**The Scottish Government
Energy Consents Unit**

**Scoping Opinion on behalf of Scottish Ministers under the
Electricity Works (Environmental Impact Assessment) (Scotland)
Regulations 2017**

**Liddesdale Wind Farm
EDF Energy Renewables Ltd**

30 October 2023

Wauchope East - 34 WTG Ref WID13135WE8-53

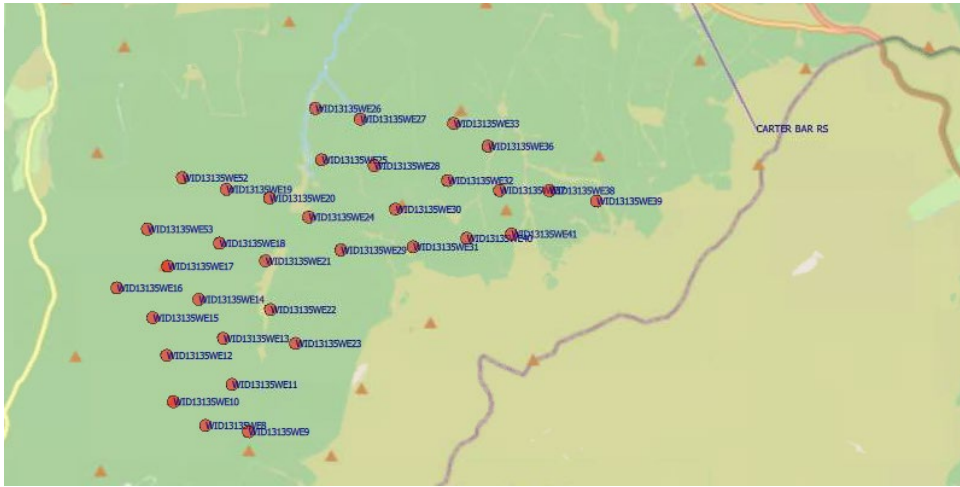
Proposed locations show they all have 100m minimum clearance

The conclusion is that the Turbine locations provided should not cause interference to BT’s current and presently planned radio network.

BT requires 100m minimum clearance from any structure to the radio link path. If the proposed locations change, please let us know and we can reassess this for you.
